8-F-21-HZ
APPLICATION FOR CERTIFICATE OF APPROPRIATENESS

701 Deery St. 37917
Fourth and Gill H

Original Print Date: 8/9/2021
 Knoxville/Knox County Planning -- Historic Zoning Commission

Level III Construction of New Primary Building

FRONT ELEVATION

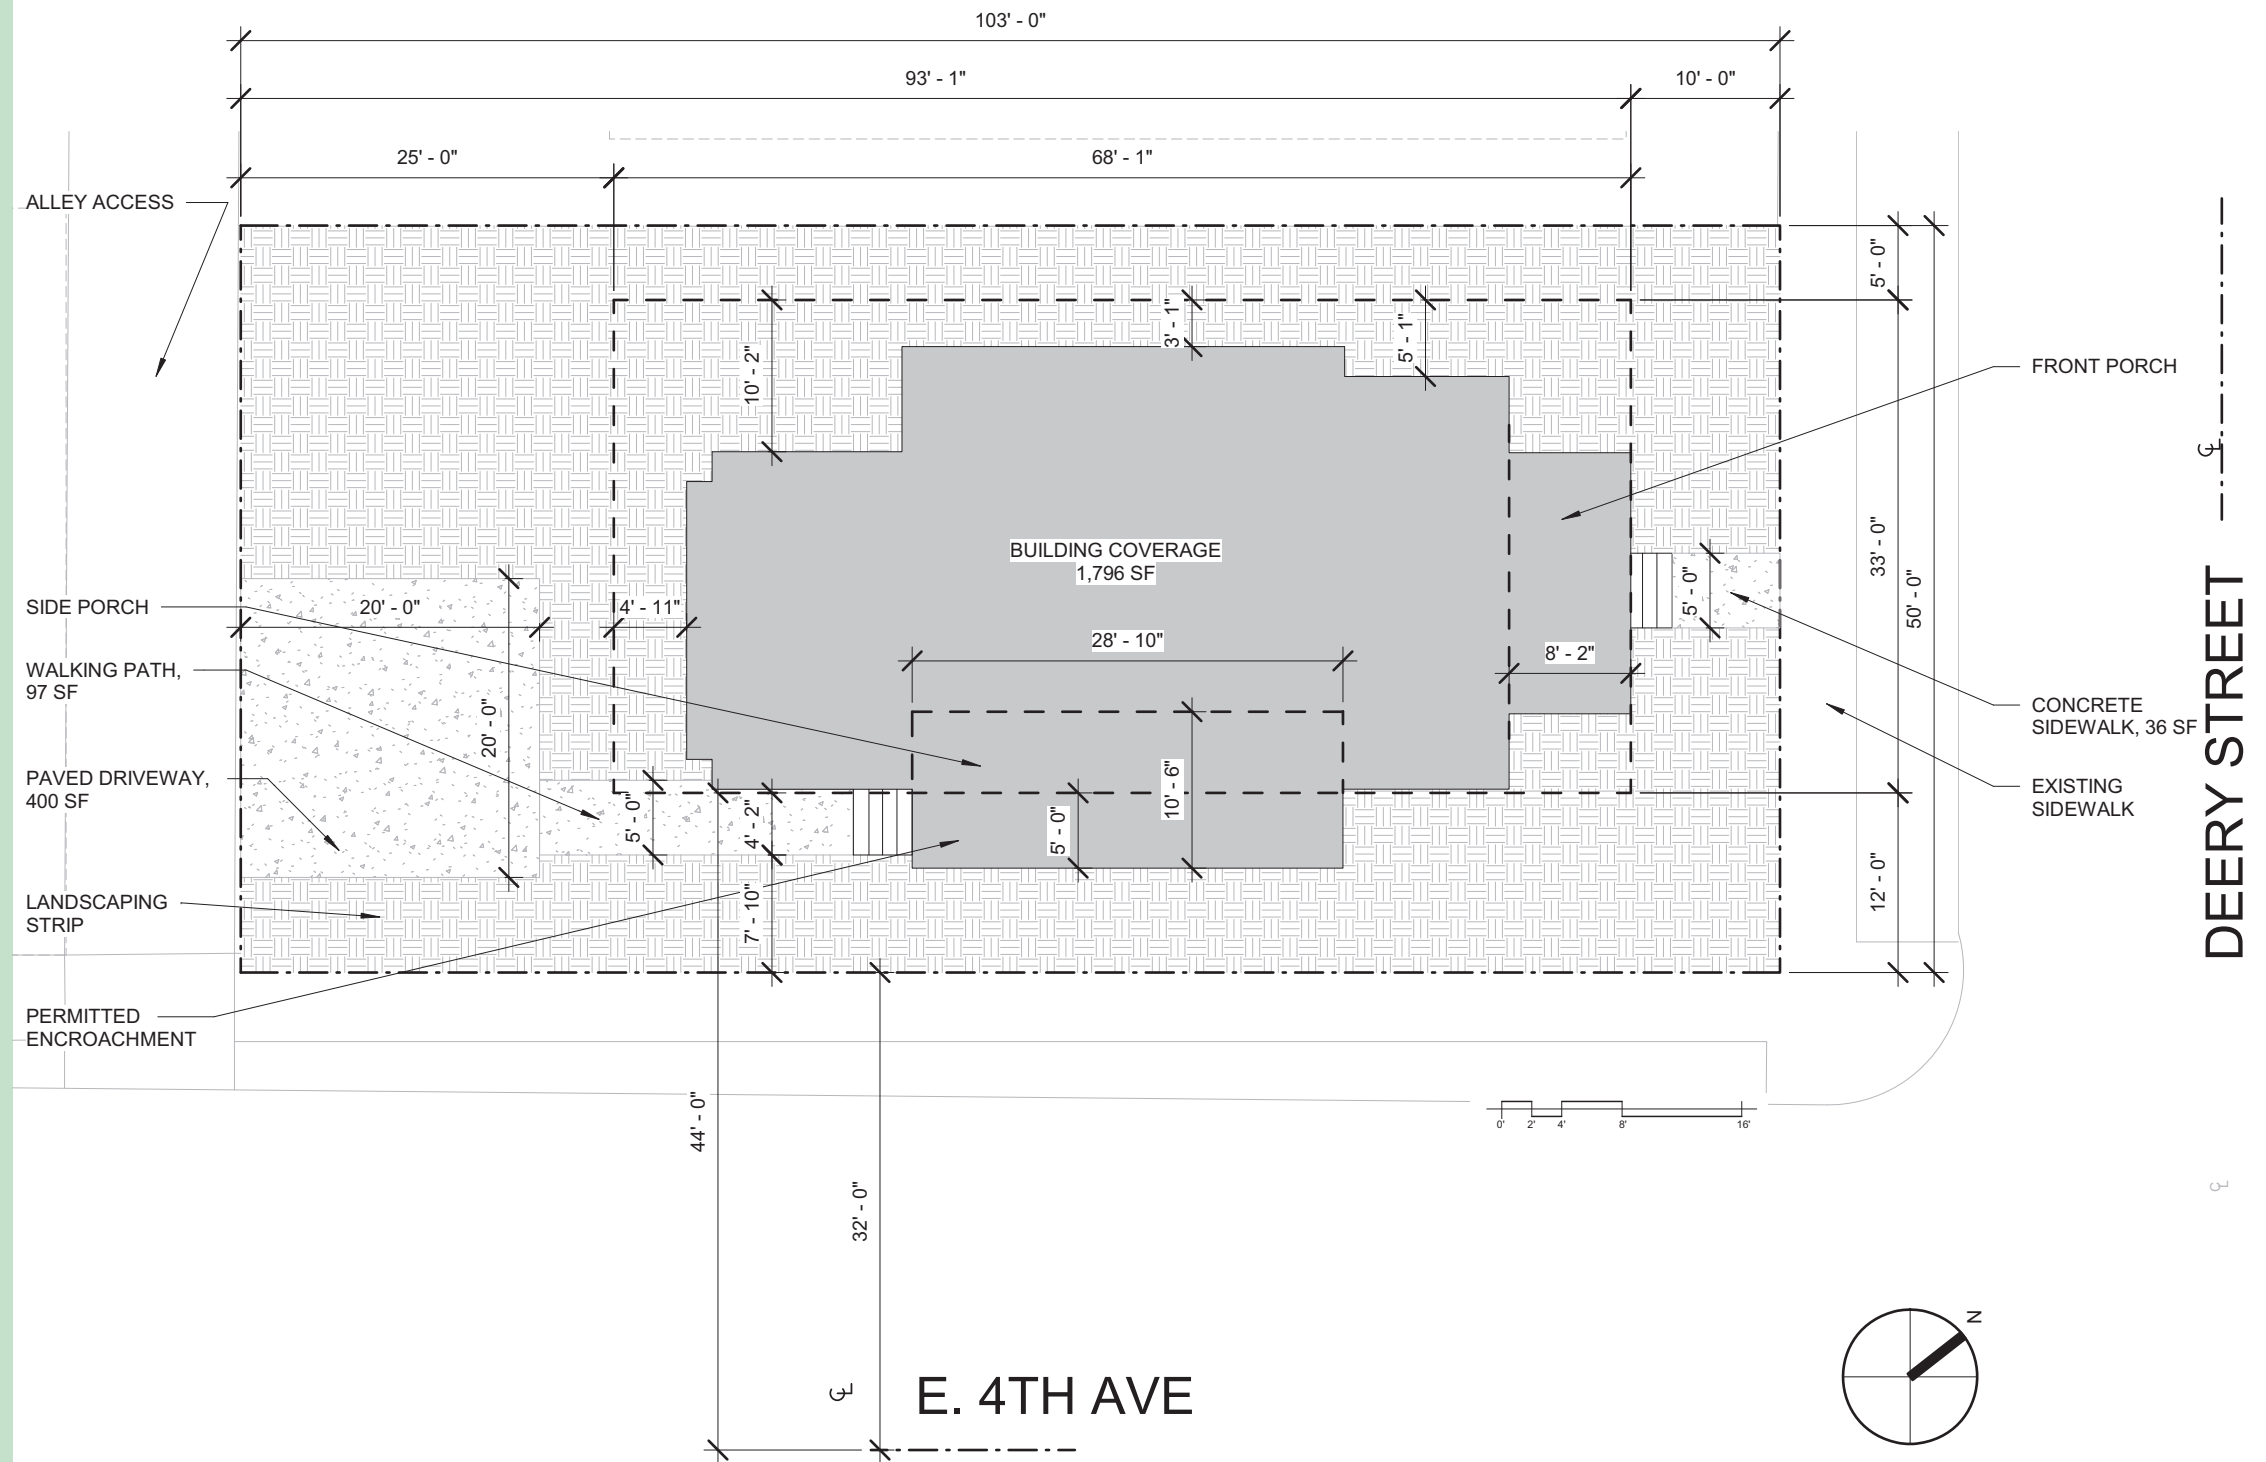
7. The façade integrates a mix of vertical and horizontal elements with horizontal trim bands, brick porch columns, and symmetrical window placement. These elements are characteristic of the Prairie style. The previously-proposed brick pilasters have been removed, in favor of vertical and horizontal trim elements.

The design incorporates substantial eave overhangs, characteristic of high-style Prairie architecture (including some outside-of-Knoxville examples provided in the application packet), especially on the facade. The application has been revised to include a separate hipped roof for the front porch, where the porch roof is set slightly lower than the primary hipped massing. This revision does assist in reducing the overall façade massing.

11. Using a centrally-located half-light door, flanked by the two square porch columns and accessible via a new concrete walkway from the sidewalk, the design successfully incorporates a strong sense of entry on the front façade.

13. The design includes an 8'-2" deep, 21' wide front porch. The porch is large in massing and scale, compared to other porches in the neighborhood. The proposed square brick columns and solid wood porch railing enclosures are consistent with the contemporary interpretation of the Prairie style. While it does contribute visual interest and complexity to a visible side elevation, the two-story, 18' wide, 12' deep side porch is also significantly larger than most porches in the neighborhood.

Pending the approval of overall massing, size, and scale, staff also recommends the additional conditions of approval: 1) final door selection to be wood and submitted to staff for approval; 2) the use of wood lap siding over HardiePlank siding; 3) using dark-colored asphalt roofing shingles and unpainted brick masonry elements to better connect with the historic context.

SOUTH EAST (FOURTH AVE) ELEVATION

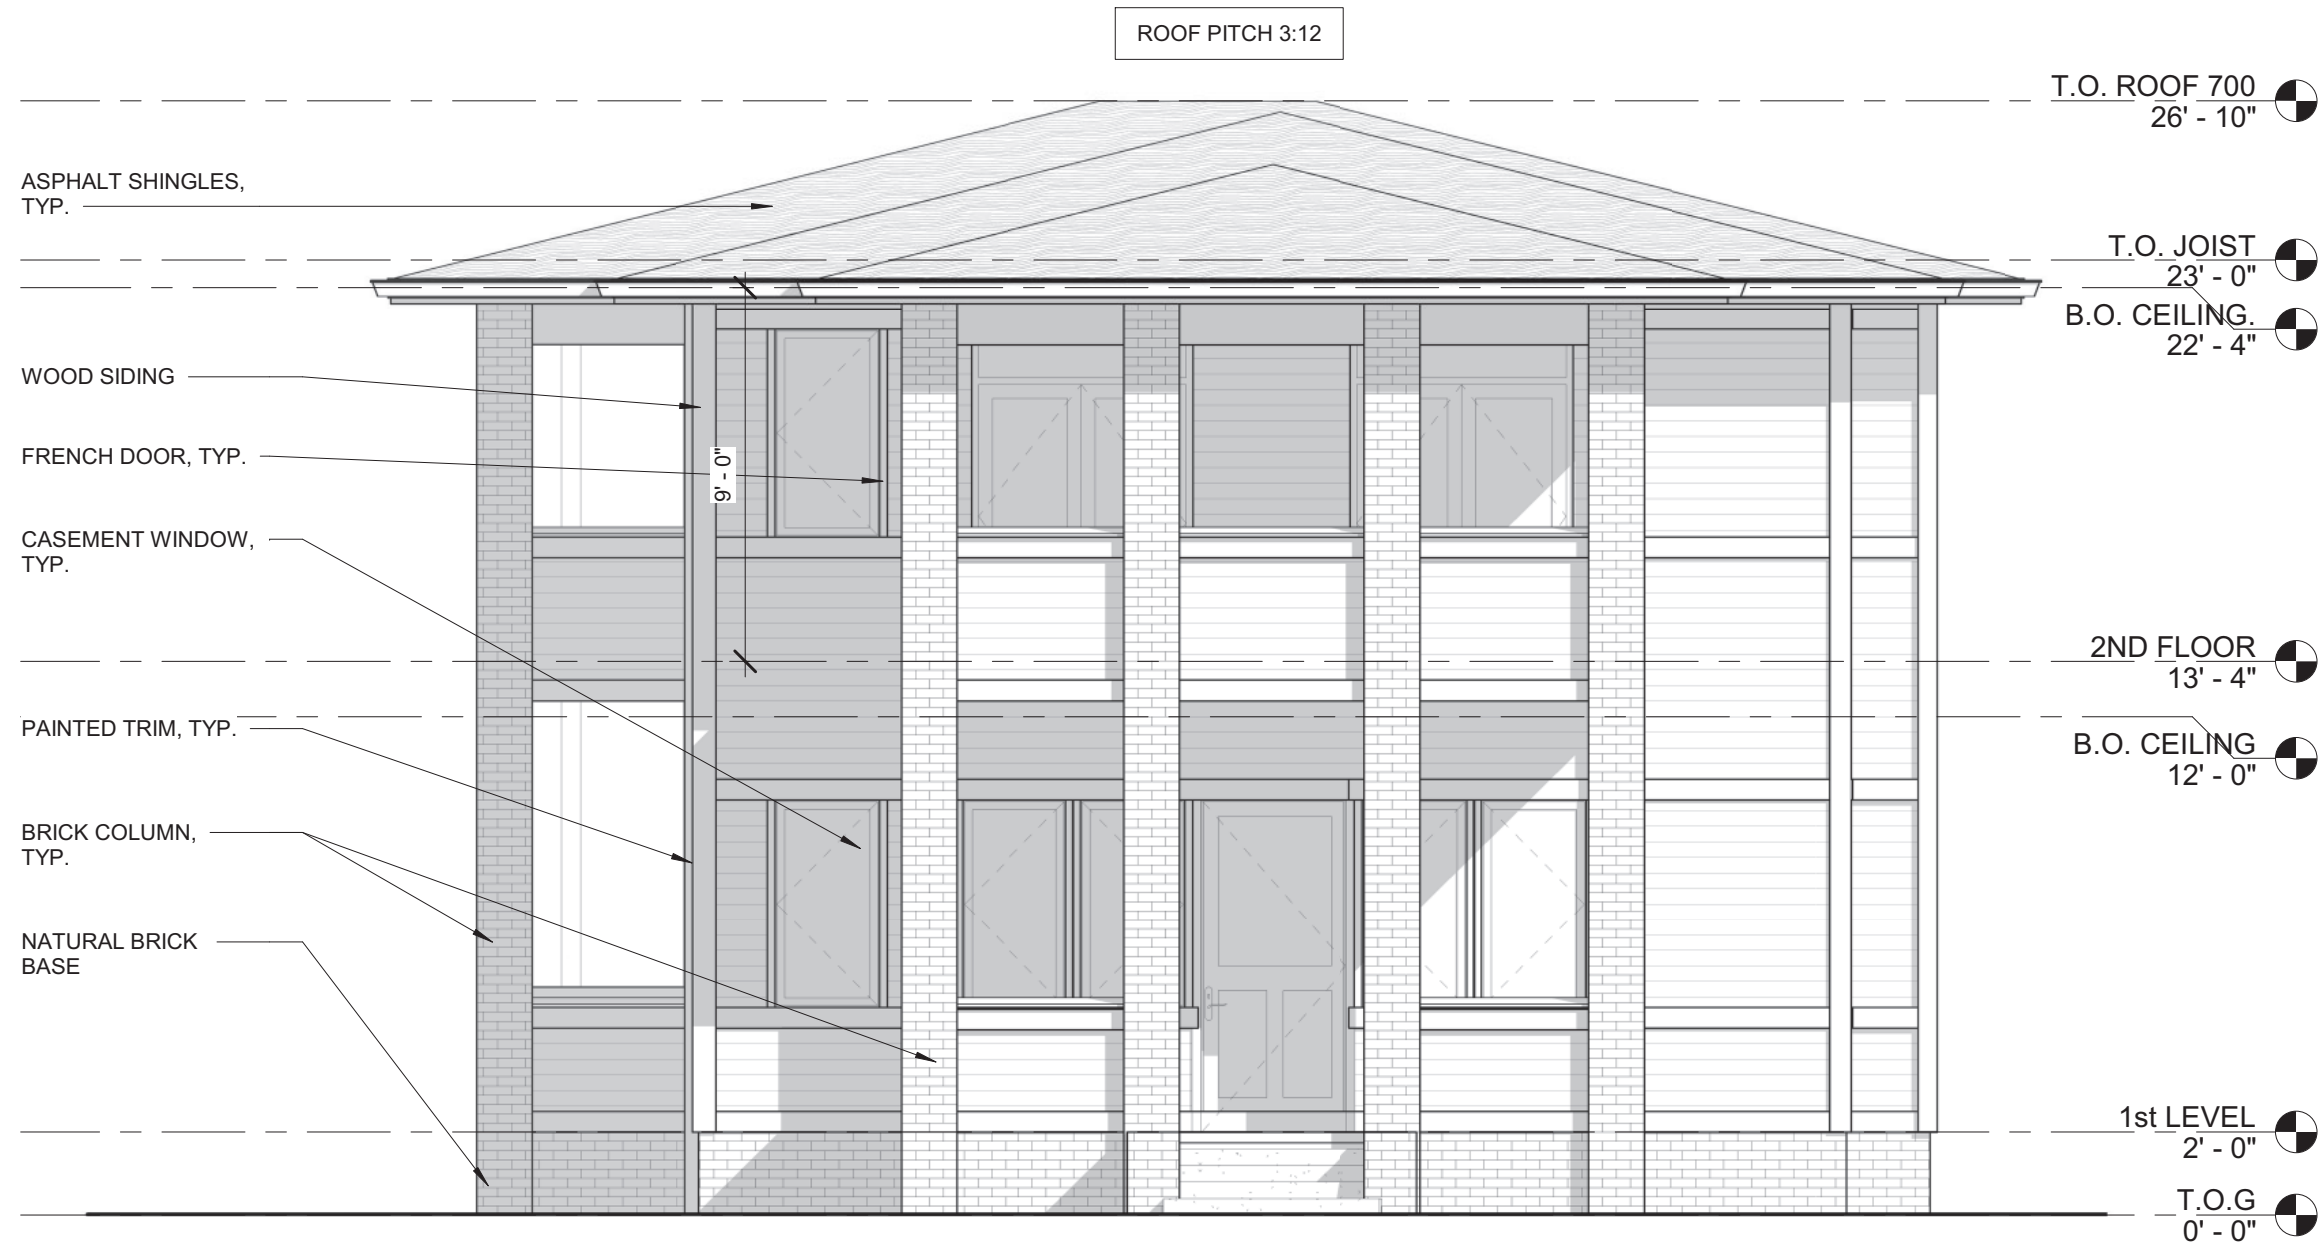
18. The application includes a substantial amount of transparency, in the form of rectangular, single-light, metal casement windows. The left (southeast) elevation fronting E. Fourth Avenue also incorporates three pairs of French doors and 5' by 5' single-light picture windows. The Commission should discuss the appropriateness of the window form and the proportions of transparency, in relation to the proposed house design and neighborhood context.

The staff recommendation remains consistent with the original review: to begin, the Commission should discuss the overall massing, size, and scale of the house as it relates to the surrounding context of the historic district. Further initial topics of discussion should focus on the patterns of transparency on the left side elevation; and any differentiation necessary between 701 Deery Street and 700 Morgan Street.
